**Contract No. HK/2009/01**

**Wan Chai Development Phase II – Central -Wan Chai Bypass at  
Hong Kong Convention and Exhibition Centre  
Updated Silt Screen Deployment Plan (Rev. 9)**

## Silt Screen Deployment Plan

Figure 1: Location Plans of Seawater Intakes

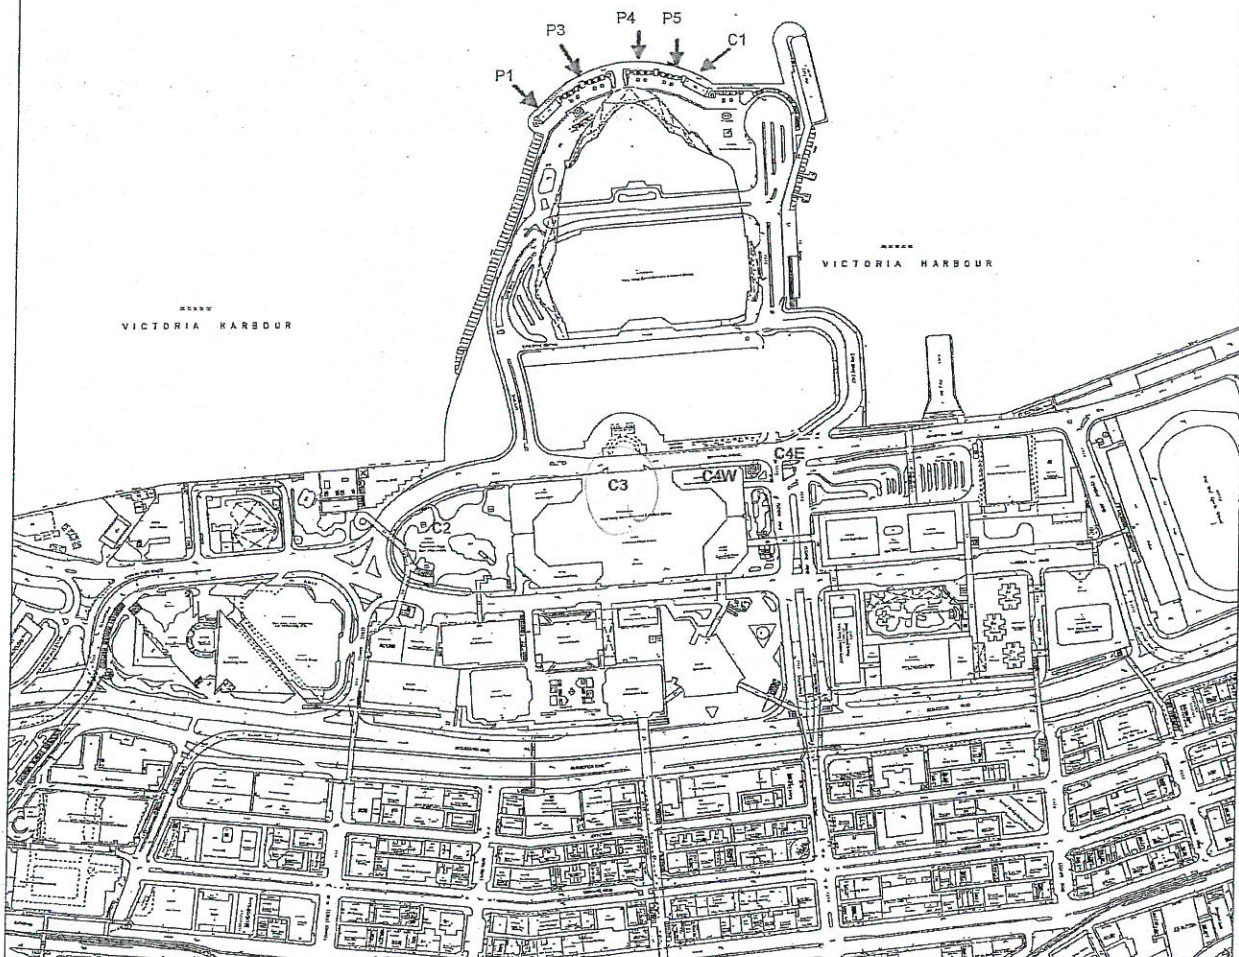
- (1) Some figures and texts in the appendixes (e.g. App.A - Location Plan; App.F - Arrange of Access Provision for Water Monitoring, etc) are so **blurred** and not easy to read, please provide figures with **higher resolution**;
- (2) Please add a paragraph to outline why amendment of plan is necessary at, say section 1.1 Introduction, to facilitate the general reader to follow the logic; and
- (3) Please review the submission to ensure the general fluency and to prevent minor grammatical mistakes.
